ENGINE - LP COMPRESSOR - PROVIDE A FAN FRAME ASSEMBLY WITH REVISED ATTACHMENT FEATURES  
- CATEGORY CODE 7 - MOD.ENG-72-0077

V2500-ENG-72-0077

Fan Frame Assembly - Before and After Alteration  
Fig.1, Sheet 1 of 2

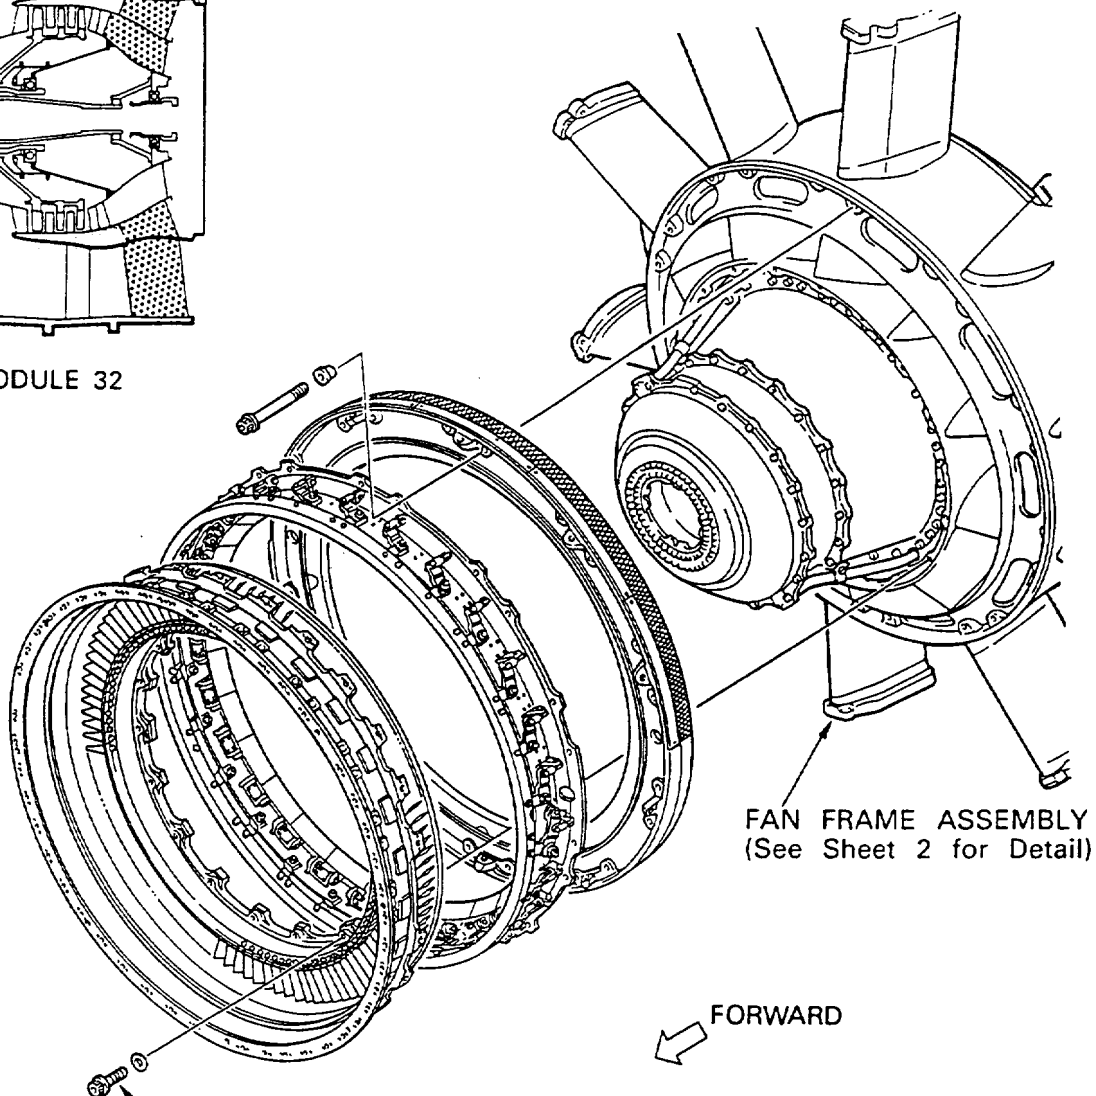
(a) The attachment features between the LPC Stage 2.5 Assembly and the Fan Frame Assembly have been changed from the plate nut/bolt to the helical coil screw insert/bolt (Refer to Figure 1).

4W0171 BOLT  
OR  
AS21517 BOLT (Before Alteration)  
4W0169 BOLT (After Alteration)
